Part # 030849-000

Proportional Controller Conversion

Replaces Part # 066544-000 Controller with Part # 066786-000

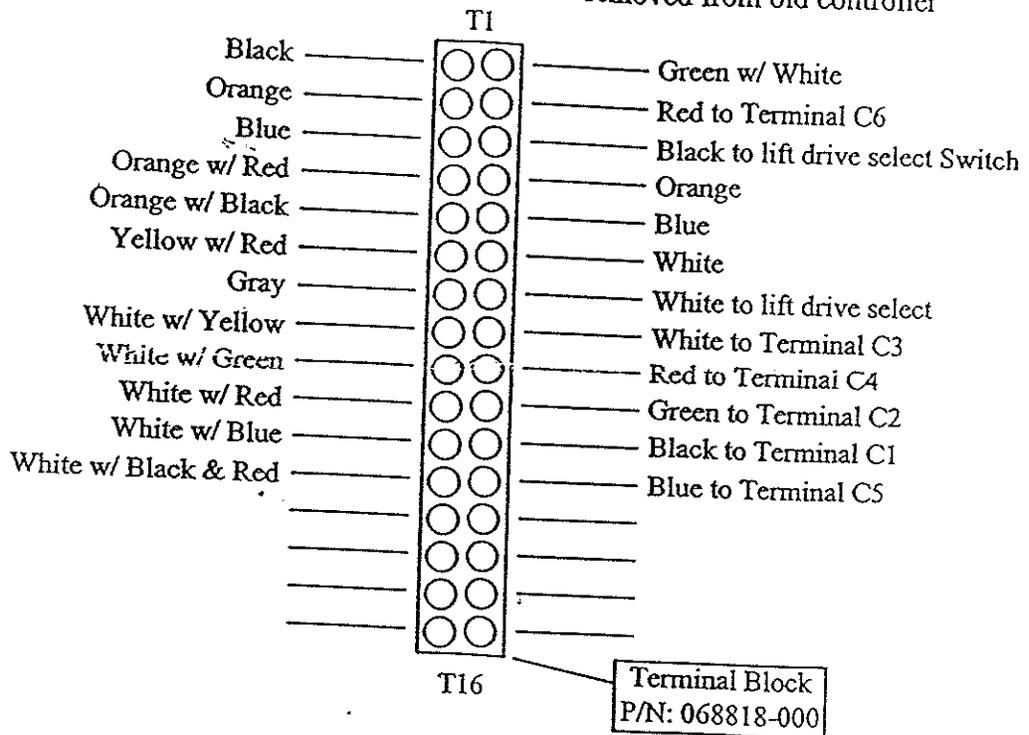
Wires on left side come from "pigtail" on controller
Wires on right side come from control cable or switches as indicated

1. Remove old controller and install new controller in control box
2. Cut 12 pin plug off of "pigtail", leaving wires as long as possible.
3. Cut terminals off control cable and switch wires removed from old controller.
4. Strip each wire and insert it into proper terminal on terminal strip P/N 068818-000, as shown on drawing above.
5. Close control box and perform full function check on new controller including checking elevated drive speed at 20 feet in 18-22 seconds.
